Access Compliance Report Public Rights-of-Way (Pedestrian Signals)

Main Street: **ORANGE_AVE** Cross Street: **S_BROOKHURST_ST** Location: **SW**

ADA ID: **SGRK210927121617** Signal Type: **One Push Button-Non APS** Overall Compliance: **No** Severity Scores: **BTN 1: 0** **BTN 2: N/A** **No BTN: N/A**

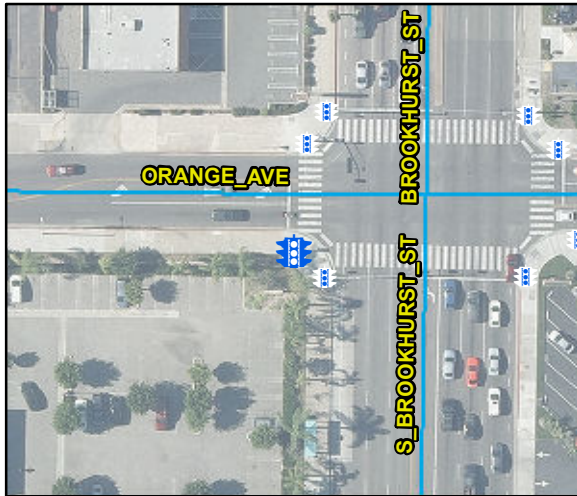
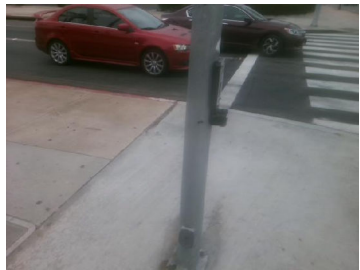
OC Std/PROW: **MUTCD 4e.08**

Possible Solutions: Replace Signal Push Button With APS Button. Remove & Relocate Sign.
